Future Scenarios' WisDOT Model Review
&
Report Documentation WisDOT Review

HCM ANALYSIS REVIEW CHECKLIST

Date(s) Reviewed (m/d/yyyy)		
Project ID(s): 1130-48-00	Highway(s)/Intersection(s): I-41 Interchanges from south of CTH BB to north of CTH S	Region: NE Region	1st Review 6/17/2019	2nd Review	3rd Review
Lead Reviewer	Name: Matt Talcott, NE Region/Vicki Haskell, BTO	Contact Information: Matthew.Talcott@dot.wi.gov; (920) 492-5716/ Vicki.Haskell@dot.wi.gov, (608) 266-8442			
Lead Analyst	Name: Jason Kessler, HNTB	Contact Information: jrkessler@HNTB.com, (608) 294-5029

MICROSIMULATION PEER REVIEW REPORT

I-41 NB Off Ramp at WIS 15/Northland (CTH OO)

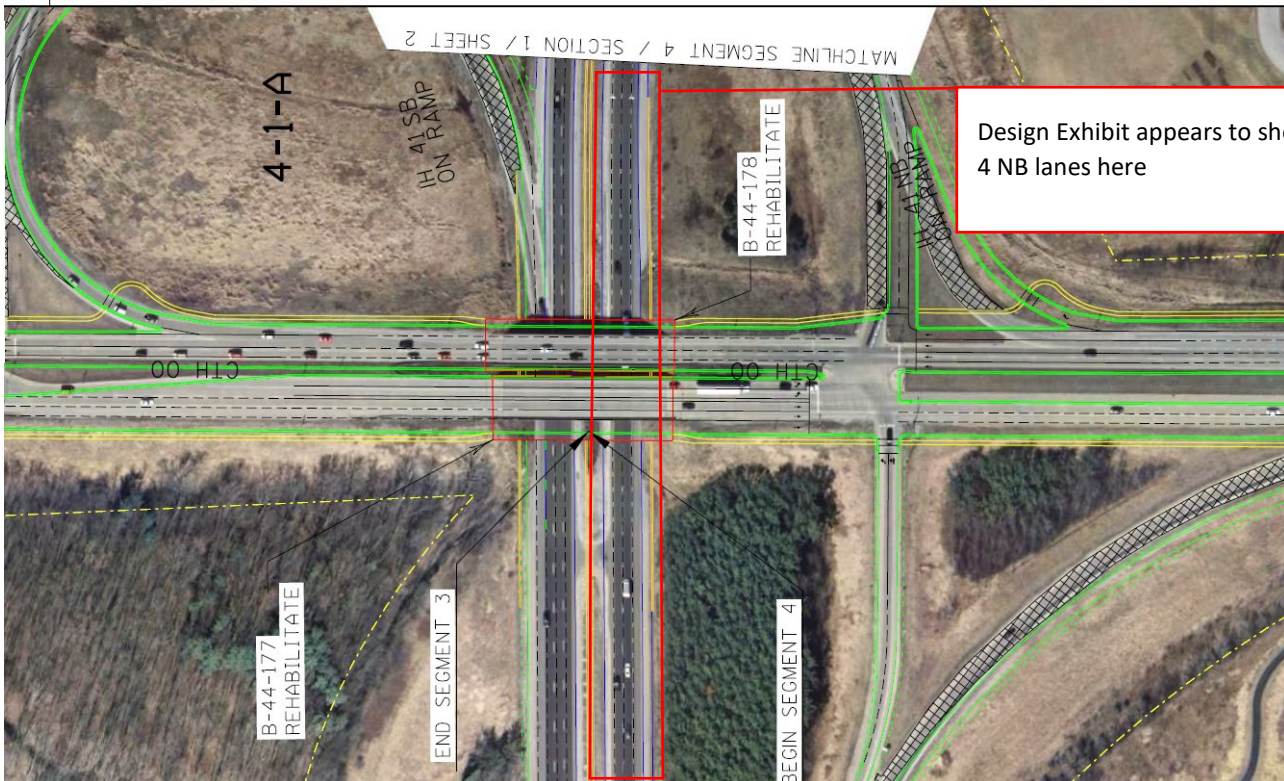
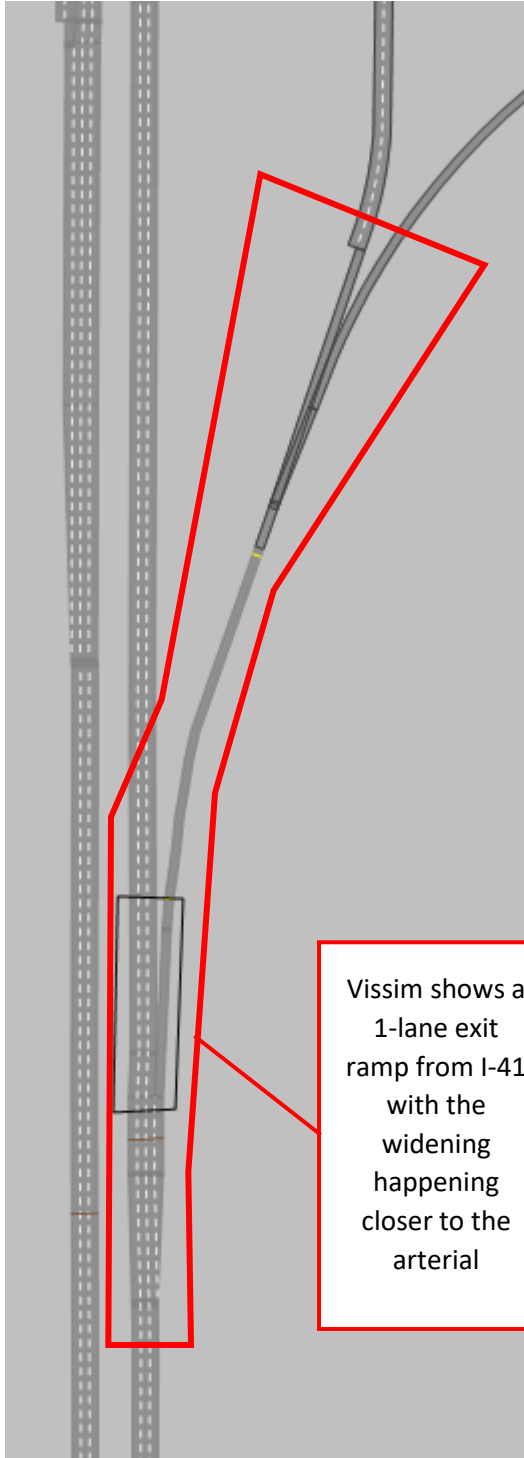
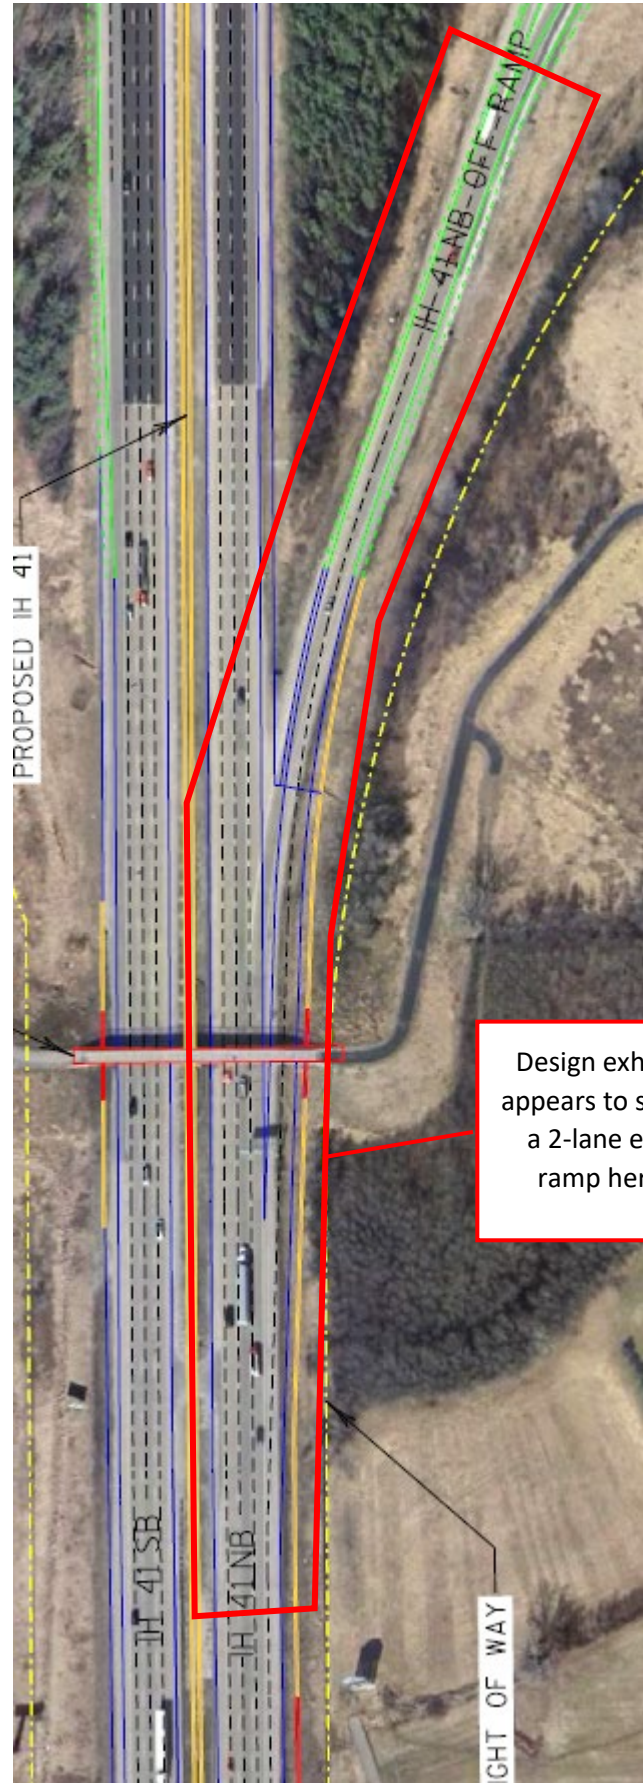
<input type="checkbox"/> <input type="checkbox"/> <input type="checkbox"/> Unacceptable/ Major Revision Required	<p>At CTH E (Ballard)/I-41 SB Off ramp, the Synchro files show only 2 EB left turn lanes exiting I-41 SB while the design files show 3 left turn lanes here. The explanation provided in the 08/30/19 email from Jason Kessler indicated that the K250 analysis only requires 2 lanes; however, the previous study recommended 3 lanes. Since the EA will likely be a K30 analysis (where the current analysis is K250), the design was left to show the triple left to provide a conservative estimate. This explanation is acceptable.</p>	
Traffic Volumes, % Trucks, Peak Hour Factor (PHF)	Acceptability	Reviewer Comment(s):	Analyst Response(s):
	<input checked="" type="checkbox"/> <input checked="" type="checkbox"/> <input type="checkbox"/> Acceptable/ No Revision Required <input type="checkbox"/> <input type="checkbox"/> <input type="checkbox"/> Conditionally Acceptable/ Minor Revision Required <input type="checkbox"/> <input type="checkbox"/> <input type="checkbox"/> Unacceptable/ Major Revision Required	<p>PHF match existing conditions. This is acceptable. However, for intersections with PHF < the HCM default (0.92), it may be acceptable to utilize a PHF of 0.92 for the 2048 scenarios.</p> <p>Using a PHF of 0.92 could eliminate the the LOS E for the EBL-T movement (PM peak) at I-41 NB ramp at CTH U (County Line Rd), the LOS E for the SBL movement (AM peak) at I41 NB ramp at CTH E (Ballard), and the LOS F for the WBR movement (AM peak) at I41 SB ramp at CTH E (Ballard).</p> <p>No additional comments.</p>

Figure 5 Short-Term Build Alternative Safety Analysis Summary

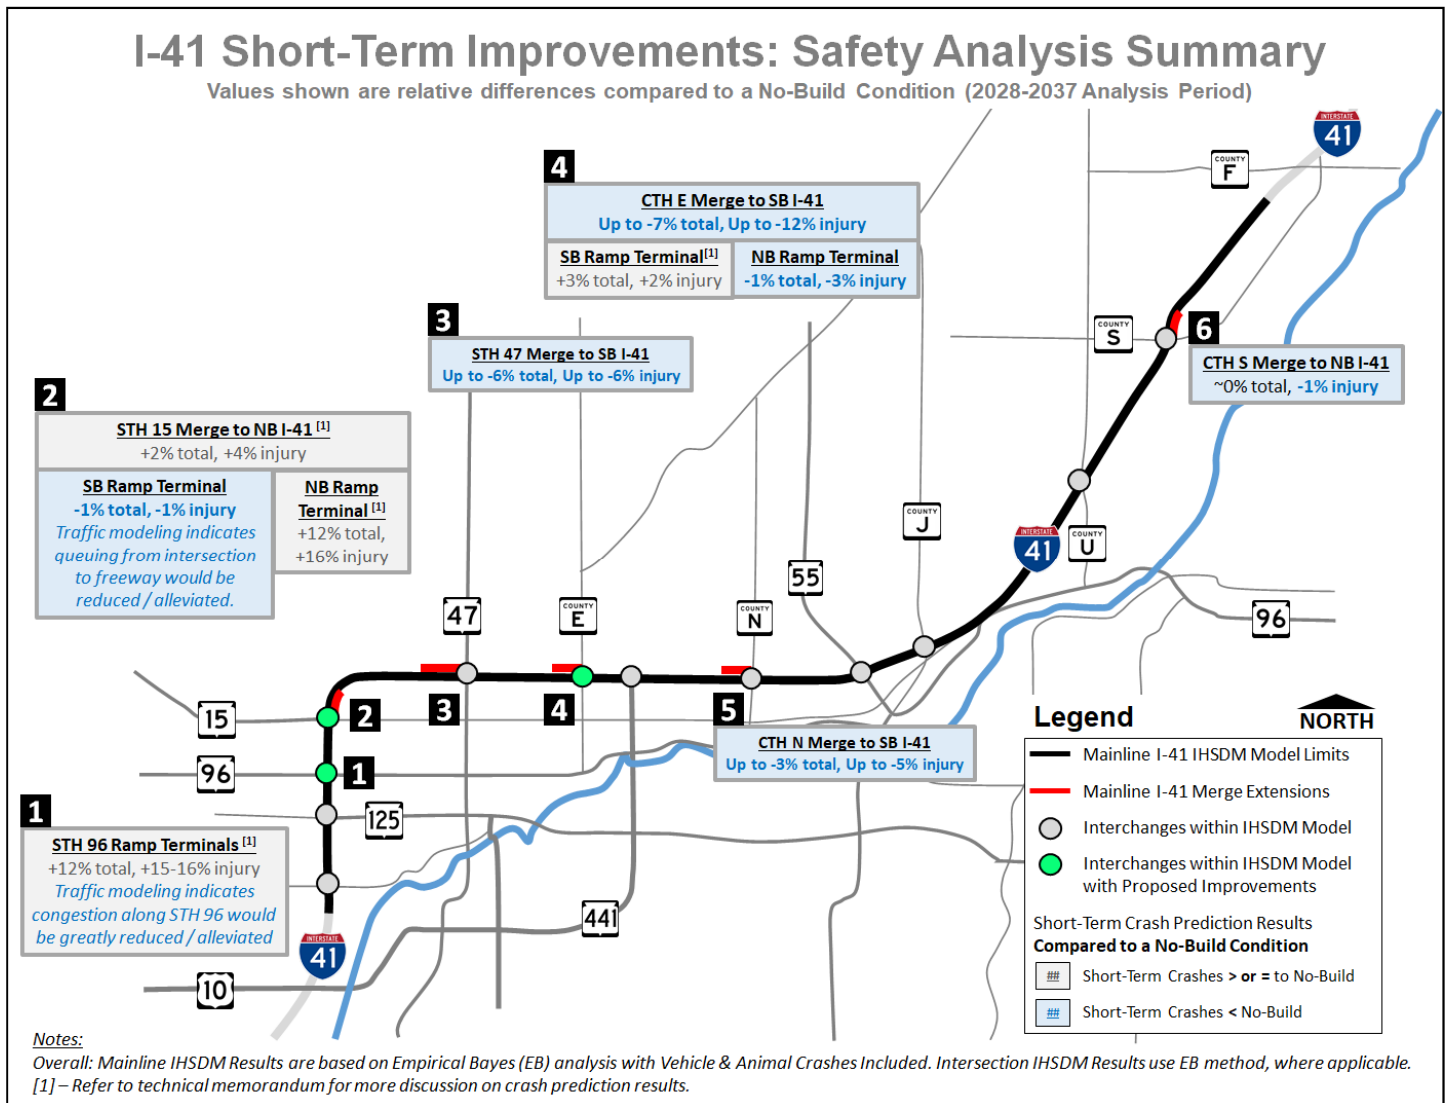
Do you want to provide a Table Similar to Table 26?

Figure 6 Analysis Segments for Long-Term Build Alternative

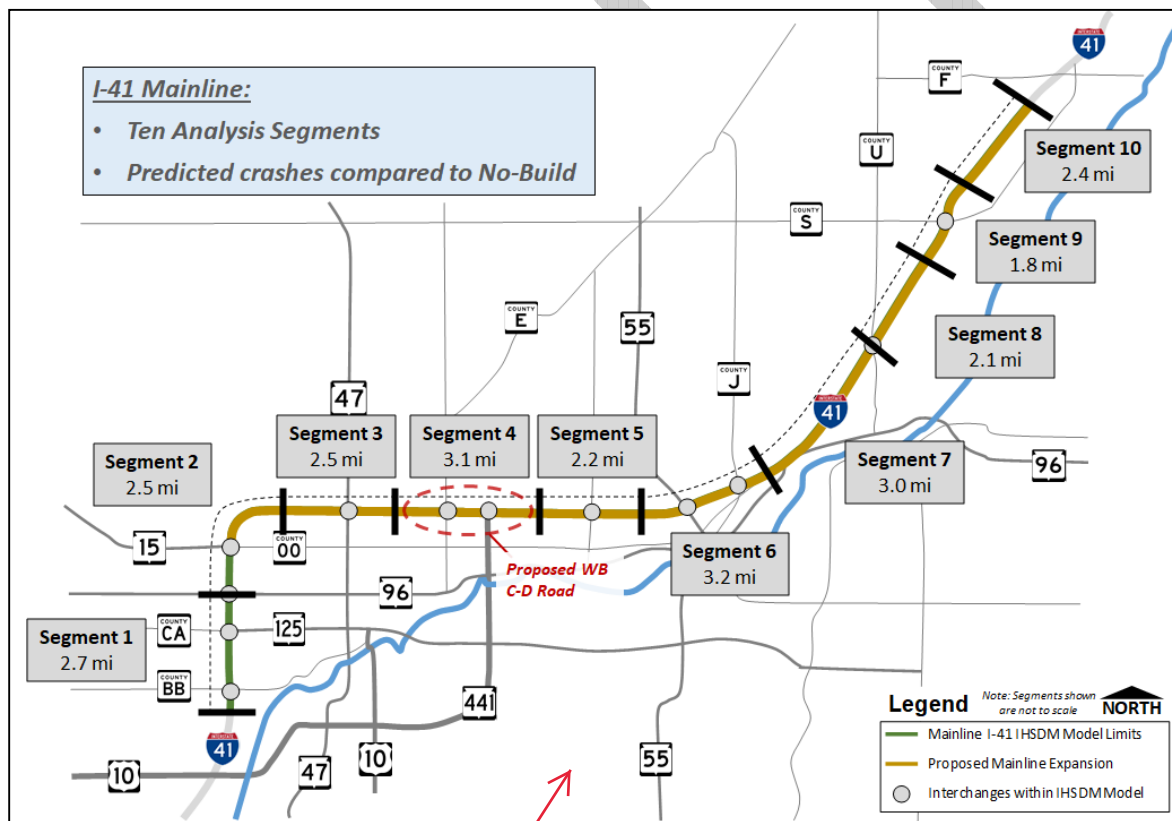
Do you want to show the change in predicted crashes, similar to Figure 5? Recommend providing consistent info.
